•			3
	SUBJECT:	Forwards add	il info in	respons	e to NRC 82011	5 request r	e
	heated junction thermocouple reactor vessel level						
	measurement sys. Info responds to Question 2 re axial						
		spacing.					
				PECET	VED:LTR J ENC	STZE	4
	DISTRIBUT	SAR/FSAR AMDT	1013 CUPIC	tod Con	veu je krade kra		an a
	IIILE: PS	DANZEGAN AMUI			respondence		
	NOTES J H	anchet 1cv	PDR Docume	nts. L	Chandler all A	mots.	05000361
	DS	Scaletti 1cy	Enviro Mat	1.		, "	· · · <u></u>
	Jh	anchett 1cy	PDR Docume	ints. L	Chandler all A	mdts.	05000362
		Scaletti 1cy

Subject: Docket Nos. 50-361 and 50-362 San Onofre Nuclear Generating Station Units 2 and 3

## HJTC Reactor Vessel Level Measurement System San Onofre Units 2 and 3

### QUESTION 2

FIGURE 2

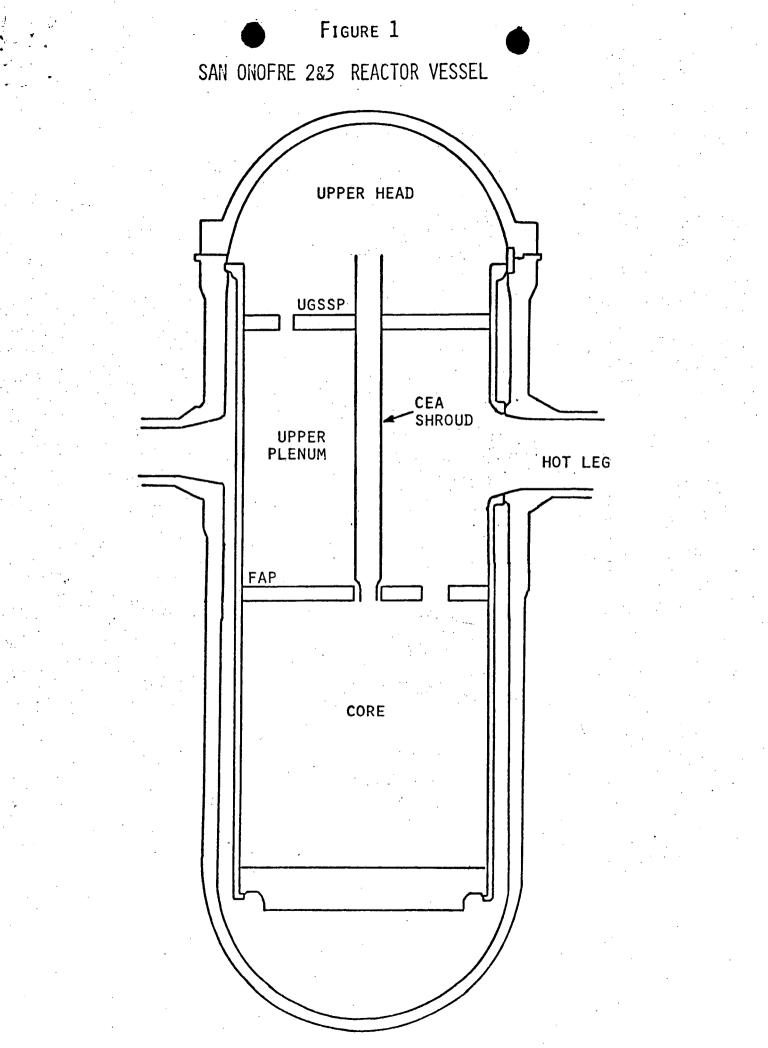
Discuss the axial spacing chosen for the HJTC sensors for Units 2 and 3.

The HJTC probe assembly for San Onofre Units 2 and 3 is designed to measure the collapsed water level in the upper head independently from the collapsed water level in the upper plenum. This is accomplished by the use of a "split" probe assembly (Figure 2). Functionally, the probe is divided into an upper separator tube in the upper head region and a lower separator tube in the upper plenum region. A divider disk inside the probe located at the UGSSP elevation isolates the upper and lower tubes hydraulically. Holes at the top and bottom of each separator tube allow the collapsed water level in each region to be formed and measured inside the separator tubes.

Therefore, the HJTC sensors are located axially in the probe assembly so that the collapsed water level in each region can be measured. The location of the eight sensors available in each of two probe assemblies are shown in Figure 2. Sensors are placed as high as possible in the upper head and upper plenum to provide an early indication of voiding in each region. A sensor just above the UGSSP indicates when the upper head is completely empty. A sensor placed midway between the upper and lower sensors in the upper head provides increased resolution for the level measurement in the upper head. In the lower separator tube, sensors are placed at the top, centerline, and bottom of the hot leg. These sensors tell the operator when the collapsed water level passes through the hot leg elevation. The final sensor is placed as close as possible to the FAP. This sensor provides an indication that the water inventory above the core in the upper plenum has been depleted and thus, gives an advanced warning of the impending core uncovery.
